**SUBJECT: RECALL R14XF PASSENGER COMPARTMENT HEATER HOSE
FAILURE**

IMPORTANT SAFETY RECALL NOTICE

**NHTSA RECALL NO. 14V-313 SCHOOL BUS
NHTSA RECALL NO. 14V-314 NON-SCHOOL BUS**

Coolant Thermostat and Passenger Compartment Heater Hose Replacement

Fig. 1

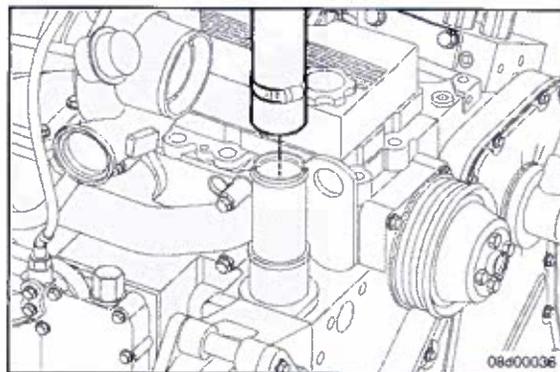
1. Park the bus on a level surface, apply parking brake, switch engine off, remove ignition key and chock wheels.
2. Disconnect batteries. (negative[-] cable first, then positive[+])
3. Drain the coolant per *Cooling System Drain, Flush & Refill* section in your Blue Bird service manual.
4. Remove the radiator hose from the water outlet connection. (Fig. 1)

Fig. 2

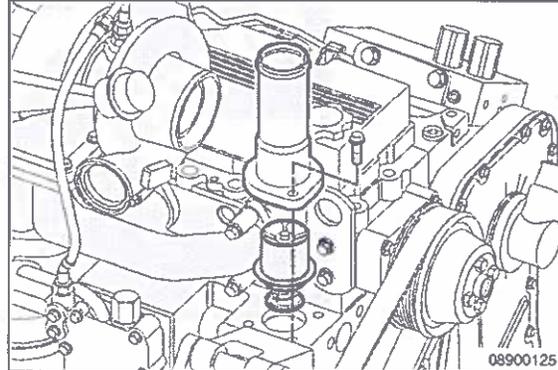
5. Remove the water outlet connection capscrews and water outlet connection. (Fig. 2)
6. Remove the thermostat and discard. (Fig. 2)

Fig. 3

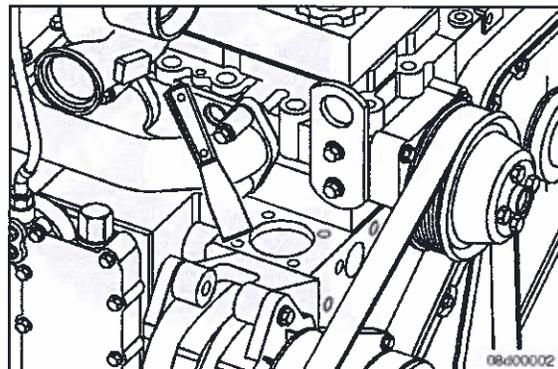
7. Clean all of the mating surfaces. (Fig 3)

NOTE: Do not let any debris fall into the thermostat cavity when cleaning the surfaces.

Fig. 4

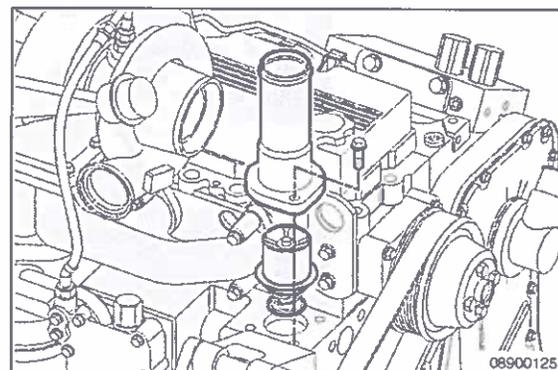
8. Install the new thermostat (BB# 10032468) into the water outlet connection. Make sure the top and bottom o-rings are in place. If the o-rings are damaged, replace with new o-rings. (Fig. 4)
9. Install the water outlet connection and mounting capscrews. (Fig. 4)
Torque Value: 24 nm [212 in-lb]

Fig. 5

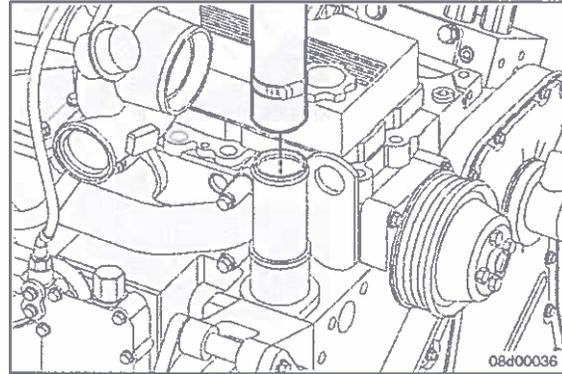
- 10. Install radiator hose on the water outlet connection. (Fig. 5)
Torque: 7.50 – 8.30 FT-LBS.
- 11. Thermostat replacement complete. Proceed to Heater Hose Replacement.

Fig. 3

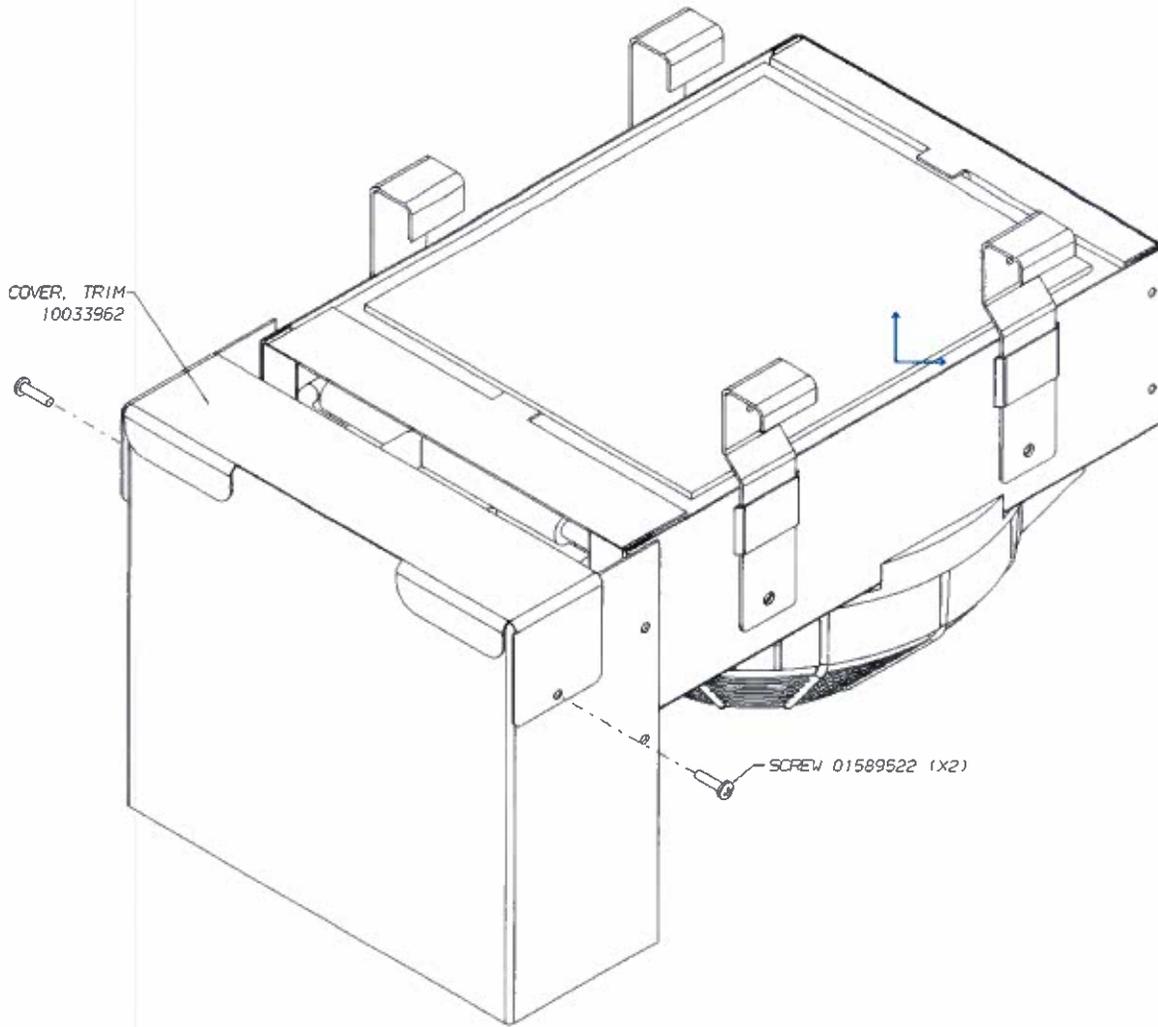
7. At each underseat heater, remove seat cushion and install heater pipe cover part no. 10033962. Back drill .056 hole on each side and attach cover with two #10 screws part no. 01589522 per Fig 3. Reinstall seat cushion
